Department of Planning and Environment

Subject: Glanmire Solar Farm (SSD-21208499) – Response to Request for Comment - Recommended Conditions of Consent

3.0 Concept Plan

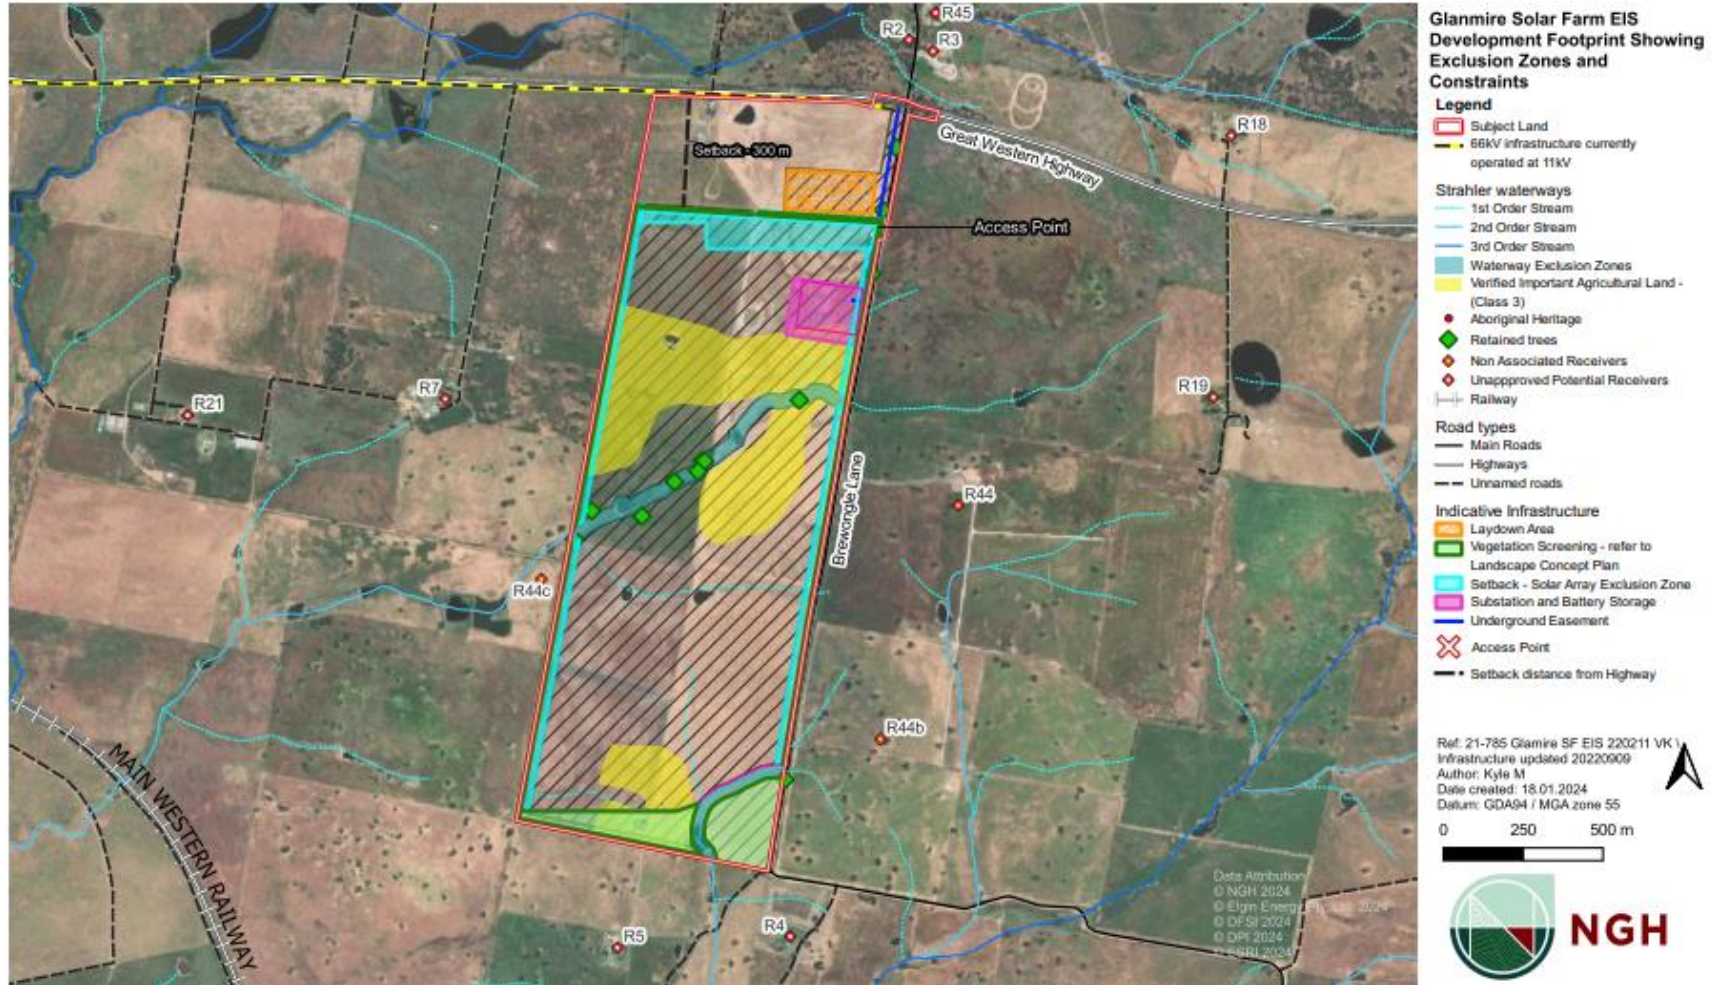
C8	Inclusion of a condition requiring an updated landscaping plan in consultation with Council and receivers	<p>Similar to B5, the Department considers that this can be resolved through the provision of an updated landscape plan figure to be included in Appendix 4, which clearly shows the increased setbacks.</p> <p>The existing landscape plan includes screening around the entire boundary of the development and the Department has confirmed with the applicant that the inclusion of a 30m APZ along the eastern and western boundaries would not require changes</p>

Proposed condition	Summary of the Commission's comment	Department's response
		<p>to the proposed plantings in terms of their design or species.</p> <p>The applicant is preparing a revised landscape plan which is provided at the end of this letter.</p>
C9	Vegetation Buffer - Introduction of requirement for the landscape screening to minimise views from the development to various receivers within 3 years of commencing operations – new provisions (c) & (d)	<p>The Department does not consider these additions to the Vegetation Buffer condition are warranted noting:</p> <ul style="list-style-type: none"> • The unmitigated visual impact rating on residences R4, R5, R7, R21 are very low to nil, as detailed in the Department's assessment. • The Technical Supplement to the Large-Scale Solar Energy Guideline 2022 notes that no mitigation is required where impacts are low to nil. • Notwithstanding, the applicant is proposing screening along the boundary of the site, beyond the requirements of the Guideline. • If this condition is to be included, the Department recommends that the timeframe be extended to 5 rather than 3 years.
